**Inspection Report, February 20, 2025 Cresson Project M-1980-244**

**MINERALS PROGRAM INSPECTION REPORT**  
**PHONE: (303) 866-3567**

| <b>MINE NAME:</b><br>Cresson Project                           | <b>MINE/PROSPECTING ID#:</b><br>M-1980-244   | <b>MINERAL:</b><br>Gold and silver                                | <b>COUNTY:</b><br>Teller    |

**Photo 10: Sump/pond at High Grade Mill, second sump to the east**

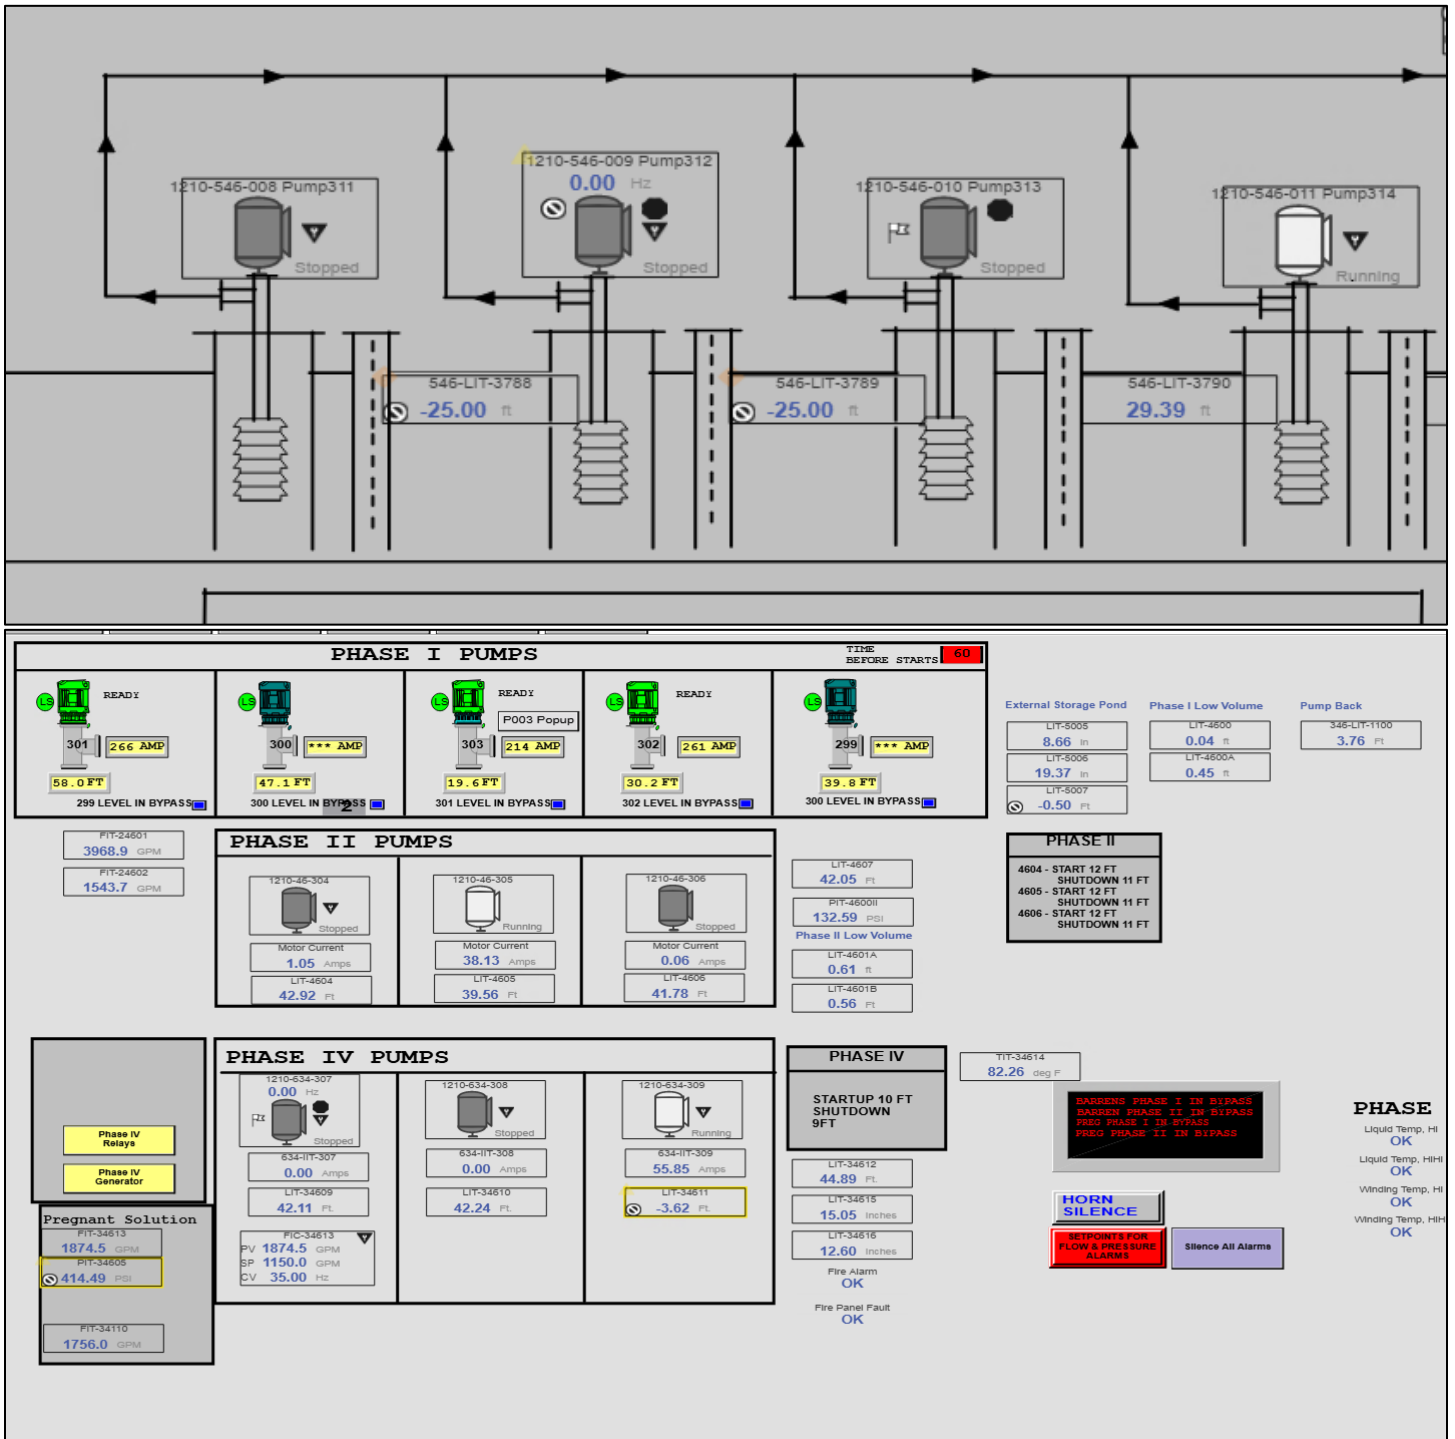
The High Grade Mill area was observed as part of this inspection. Amendment 14, which is currently under review by the Division, proposes demolition of the high grade mill and a leach pad expansion in this area. The

Division confirmed that the proposed pad expansion would cover the entirety of the high grade mill footprint and extend west into the valley. The pad would also extend to the east. The High grade Mill was originally built on liner, but this liner construction was not certified in the same way that the current permit requires. Therefore, the proposed expansion pad will be constructed on all new structural fill and certified liner, just as the other areas of the VLF have been constructed. Construction of the new pad would require relocation of a freshwater tank, used for ADR2, and two topsoil piles. The pump back system and surface sumps in this area (Photo 10) would be eliminated with this expansion plan. The surface sumps in this area currently pump stormwater and underdrain water to VLF1. Nearly all leach solution utilized in this new pad area would report to VLF2, with a minor amount reporting to VLF1. A contingency plan is briefly noted in Amendment 14, which states that the High Grade Mill may potentially re-open for processing. The mill has not been up and running since January of 2022. All work done to the mill since then has been in general maintenance of the facilities. The Division toured the mill facility during the inspection. Site personnel stated that while the mill could feasibly be put back into production, this would be a fairly large undertaking. Reuse of the mill would present options for processing which may rely on designated chemical treatment, but could also be re-opened and process material without these chemicals, relying on flocculant and filter press methods for extraction instead. The Division noted that if designated chemicals were to be used again in the mill, secondary containment for tanks external to the mill should be confirmed before production begins. Currently, secondary containment for many of these tanks is predominantly made up of a concrete pad with an ~1.5 foot tall lip (Photo 11).

**Photo 12: Photograph sent to the Division on February 13, 2025 regarding the 2/11/25 washout event on VLF2.**

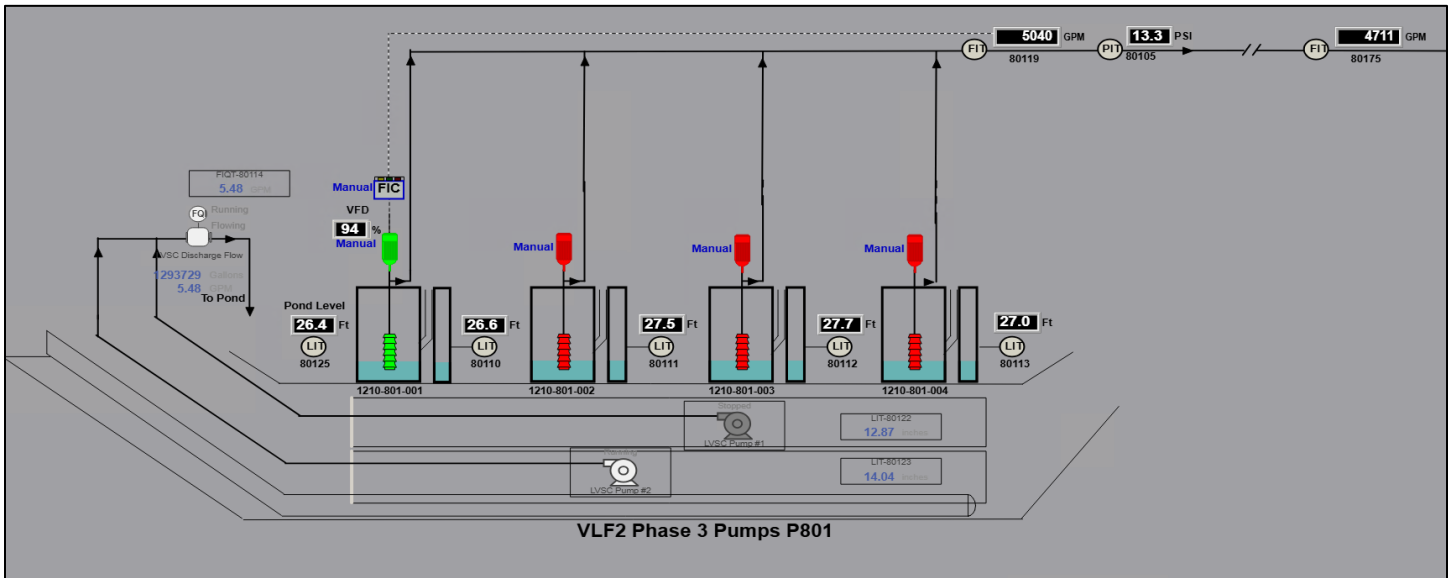
The Division received a courtesy notification from the site on February 13, 2025 regarding a washout event that occurred on February 11<sup>th</sup> at VLF2 Phase 2A at the 10,300 elevation. The email was sent as a courtesy notice and not as an official notification which would be required pursuant to Rule 8.1. However, site representatives stated that the geotechnical team had not yet completed their investigation of the event and thus, site personnel were awaiting these results before attempting to backfill and repair the feature. The material was said to have traveled to the catch bench below but had not traveled anywhere off liner. Site reps also stated that no ponded solution was visible atop the area that washed out. No active leaching is occurring in the area while the event is under investigation. The Division confirmed the presence and location of the washout during this inspection. The washout is located on the north-facing slope of VLF2, directly south of Schist Island (Photo 8). The feature appeared to be small to medium in size when compared to previous washout events on site. The feature does not appear to have progressed in size or severity since the initial notification photograph was sent to the Division (Photo 12). The Division has requested to remain updated on the outcome of geotechnical investigation, regardless of whether or not a Rule 8.1(a) notification is required.
